Product Change Notice

Issue Date: 31 Dec 2013
Revision Date: 29 May 2015

To change 5mm Lamp leadframe thickness from 25mils to 18mils.

Package height(dimension D) change correction for standoff part number

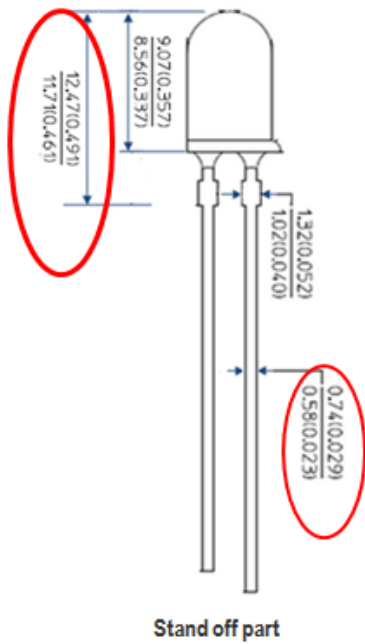
HLMP-3950	HLMP-3651	HLMP-D105
HLMP-3950-MNC00	HLMP-4101	HLMP-D105-M0002
HLMP-3950-K0001	HLMP-3680	HLMP-3600-D00B2
HLMP-3950-K0002	HLMP-3680-B00B2	HLMP-3600
HLMP-3950-K00B2	HLMP-3681-B0000	HLMP-3850
HLMP-3950-LM000	HLMP-3590	HLMP-3850-K0002
HLMP-3750	HLMP-3650-C00B2	HLMP-3850-K00B2
HLMP-3750-L00B2	HLMP-3650	HLMP-D155
HLMP-3750-L0002	HLMP-3601	HLMP-D155-F0002
HLMP-3390	HLMP-3490

Part number	Dimension D	Part number	Dimension D	
HLMP-3950	12.45 mm to 13.25mm	HLMP-3600	11.54mm to 12.34 mm	
HLMP-3950-MNC00		HLMP-3600-D00B2		
HLMP-3950-K0001		HLMP-3601		
HLMP-3950-K0002		HLMP-3650		
HLMP-3950-K00B2		HLMP-3650-C00B2		
HLMP-3950-LM000		HLMP-3651		
HLMP-3750		HLMP-3680		
HLMP-3750-L00B2		HLMP-3680-B00B2		
HLMP-3750-L0002		HLMP-3681-B0000		
HLMP-3850		HLMP-3390		10.87mm to 11.67mm
HLMP-3850-K0002		HLMP-3490		
HLMP-3850-K00B2		HLMP-3590		
HLMP-4101				
HLMP-D155				
HLMP-D155-F0002				
HLMP-D105				
HLMP-D105-M0002

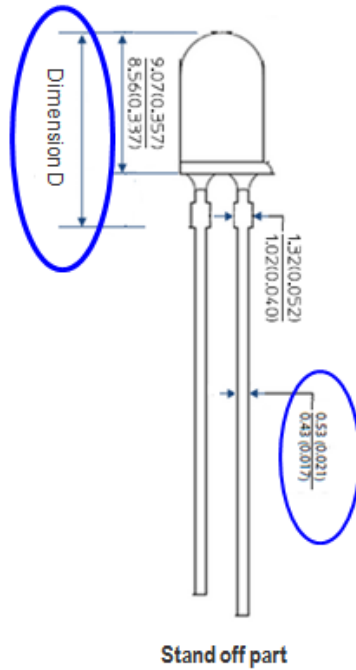
25mils leadframe thickness for existing 5mm Lamp (for above part numbers) will be replaced by 18 mils leadframe thickness. There is no change in device functionality and electrical performance.

Existing 25mils leadframe

18mils leadframe

No impact to product performance as the only difference is in the leadframe thickness and package height (dimension D)
 This 18mils leadframe is an existing leadframe that is being used in production for other 5mm lamp part numbers.

- Recommended PC board plated through holes (PTH) size for LED component leads:

LED Component Lead Size	Diagonal	Plated Through-Hole Diameter
Lead size (typ.)	0.45 × 0.45 mm (0.018 × 0.018 in.)	0.636 mm (0.025 in)	0.98 to 1.08 mm (0.039 to 0.043 in)
Damper shear-off area (max.)	0.65 mm (0.026 in)	0.919 mm (0.036 in)

- Customer is advised not to assemble LEDs with 25mils and 18mils leadframe on the same board.
